# Access Compliance Report

## Public Rights-of-Way

Intersection ID: 48243	Main Street: YELLOWSTONE_SPRINGS_LN	Cross Street: NORMANS_LANDING_DR	Location: SE
ADA ID: B255F9892305	Ramp Type: PerpDiag	Initial Pass/Fail: Fail	Overall Compliance: No
Severity Score: 37.5			
Codes/Mitigation Info/Possible Solution		Field Measurements/Component Compliance

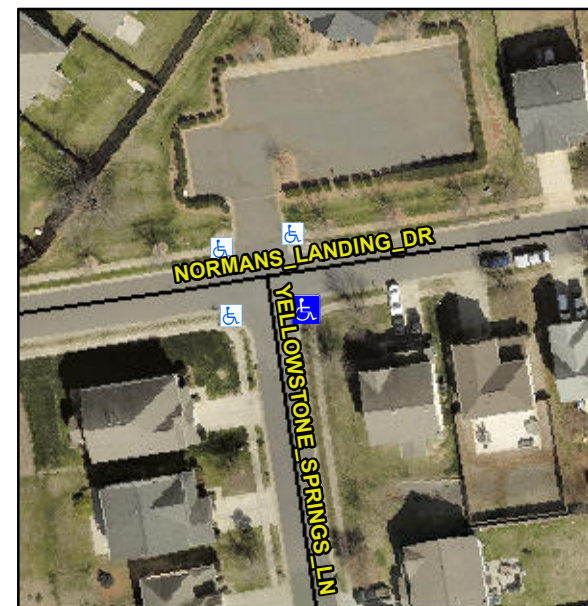
**Remove & Replace Curb Ramp With Two New Directional Ramps or Equivalent.**

**R304.2.2, R304.5.3**

Compliance	Description	Data	Compliance	Description	Data
N/A	Ramp Length (in)	49.0	No	Ramp Slope (%)	9.6
Yes	Ramp Width (in)	48.0	No	Ramp XSlope (%)	8.9
N/A	Flare Type LT	N/A	N/A	Flare Type RT	N/A
N/A	Flare Slope LT (%)	N/A	N/A	Flare Slope RT (%)	N/A
N/A	Flare Traversable LT?	N/A	N/A	Flare Traversable RT?	N/A
N/A	Landing Length (in)	N/A	N/A	DWS Provided?	N/A
N/A	Landing Width (in)	N/A	N/A	DWS Contrast?	N/A
N/A	Landing Slope (%)	N/A	N/A	DWS Length (in)	N/A
N/A	Landing X Slope (%)	N/A	N/A	DWS Full Width?	N/A
N/A	Landing Curb? (Y/N)	N/A	N/A	DWS Offset (in)	N/A
N/A	Shared Landing?	N/A			
N/A	Gutter Ponding?	N/A	N/A	Gutter Slope (%)	N/A
N/A	Gutter Lip Ht (in)	N/A	N/A	Gutter X Slope (%)	N/A
N/A	Painted X Walk1?	No	N/A	Painted X Walk2?	No
	X Walk 1 Direction	To N		X Walk 2 Direction	To W
N/A	X Walk 1 Width (in)	N/A	N/A	X Walk 2 Width (in)	N/A
	X Walk 1 Slope (%)	1.2		X Walk 2 Slope (%)	5.8
	X Walk 1 X Slope (%)	7.9		X Walk 2 X Slope (%)	4.9
